SOLICITATION AMENDMENT
MODIFICATION DE L'INVITATION

Title - Sujet MONITOR ARMS & KEYBOARD TRAYS	
Solicitation No. - N° de l'invitation 60074-130582/A	Amendment No. - N° modif. 004
Client Reference No. - N° de référence du client 60074-130582	Date 2014-04-24
GETS Reference No. - N° de référence de SEAG PW-\$\$\$PQ-930-64865	
File No. - N° de dossier pq424.60074-130582	CCC No./N° CCC - FMS No./N° VME
Solicitation Closes - L'invitation prend fin at - à 02:00 PM on - le 2014-04-30	Time Zone Fuseau horaire Eastern Daylight Saving Time EDT
F.O.B. - F.A.B. Plant-Usine: <input type="checkbox"/> Destination: <input checked="" type="checkbox"/> Other-Autre: <input type="checkbox"/>	
Address Enquiries to: - Adresser toutes questions à: Chalmers, Brianna	Buyer Id - Id de l'acheteur pq424
Telephone No. - N° de téléphone (819) 956-5660 ()	FAX No. - N° de FAX () -
Destination - of Goods, Services, and Construction: Destination - des biens, services et construction: Finance Canada Receiving Room P-155 L'Esplanade Laurier, West Tower 300 Laurier Ave. West Ottawa, ON K1A 0G5

This amendment is raised to answer questions received from industry and modify the Solicitation as follow :

1- At Annex A, Section 5.1.1:

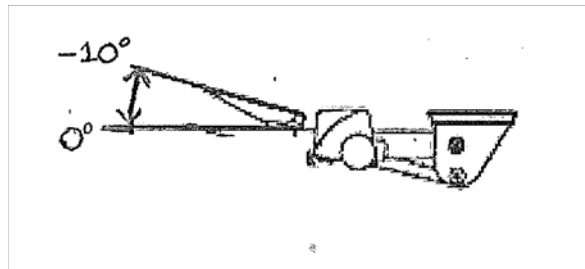
Delete: Must be capable of being continuously height adjusted by the user with or without a lever to any position within a minimum range of 203mm (8"), 76.2mm (3") below and 25mm (1") above the terminal support surface. Once the support surface has been locked in the desired position, the support surface must remain stable during the normal keying process.

Insert: Must be capable of being continuously height adjusted by the user with or without a lever to any position within a minimum range of 153 mm (6") and a minimum of 25mm (1") above the terminal support surface. Once the support surface has been

locked in the desired position, the support surface must remain stable during the normal keying process.
